Work Order ID 161216

Item Name: Strut

APICAL INDUSTRIES, INC.	ENGINEERING CHANGE NOTICE NO. 04274			SHEET 1 OF 1	
	DWG NO. 646.3500	REV: NC	PREPARED BY J. SOTO	DATE: 12/02/2013	EFFECT ON DWG ☐ INC. ☒ UNINC.
	DWG TITLE: STRUT				
APPROVED BY: ENGR <i>[Signature]</i>		MFG <i>[Signature]</i>	QC <i>[Signature]</i>	EFF. NEXT ORDER	
TRANSACTION CODES (TC): A-ADD R-REVISE C-CREATE D-DELETE		REASON: REVISED DELTA NOTE 1 & 2.

SHEET 2 IS:

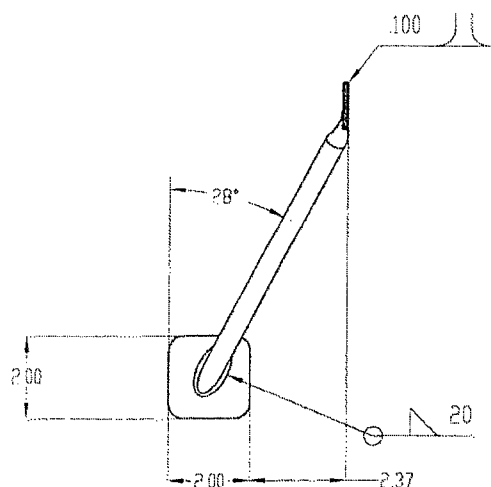
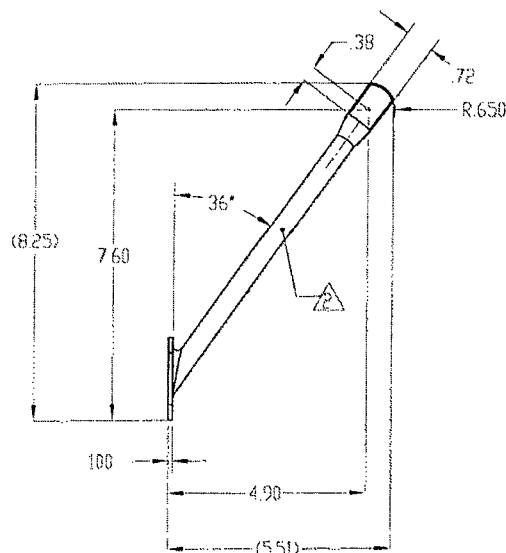
APICAL INDUSTRIES, INC.	ENGINEERING CHANGE NOTIC. NO. 02440			SHEET 1 OF 1	
	DWG NO. 646.3500	REV: NC	PREPARED BY S. HUFF	DATE 06/08/09	EFFECT ON DWG ☐ INC. ☒ UNINC.
	DWG TITLE: STRUT				
	APPROVED BY: ENGR <i>[Signature]</i>	MFG <i>[Signature]</i>	QC <i>[Signature]</i>	EFF. CURRENT ORDER AND STOCK	
TRANSACTION CODES (TC): A-ADD C-CREATE R-REVISE D-DELETE		REASON: REVISED GEOMETRY TO ACCOMMODATE NEW EXISTING AIRCRAFT PROVISIONS

646.3512 SHOWN
646.3513 OPPOSITE

SHEET 2, IS:

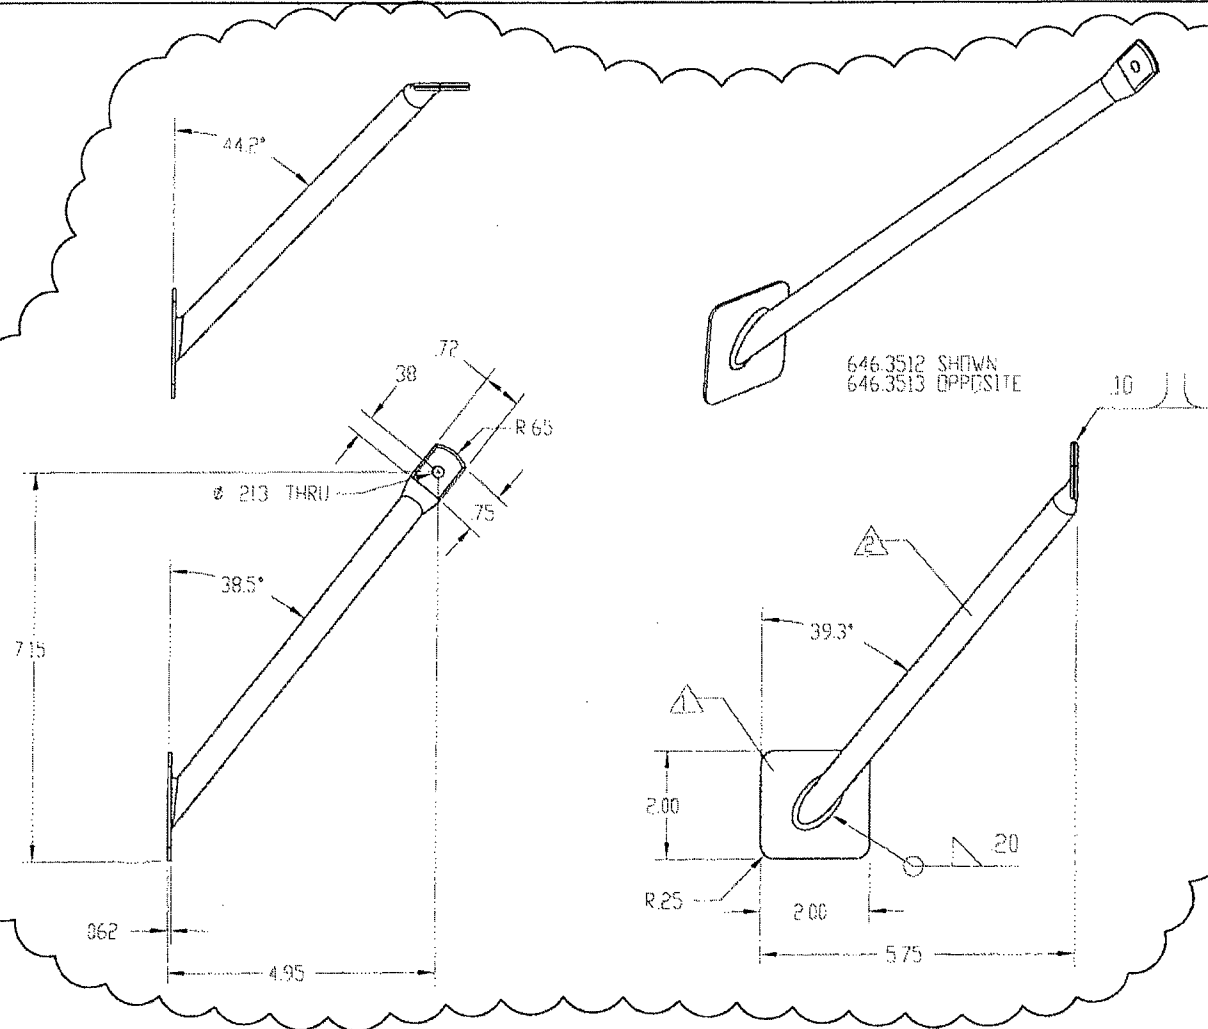
REASON: REVISED ANGLE OF 646.3512 & 646.3513 FOR BETTER FITMENT
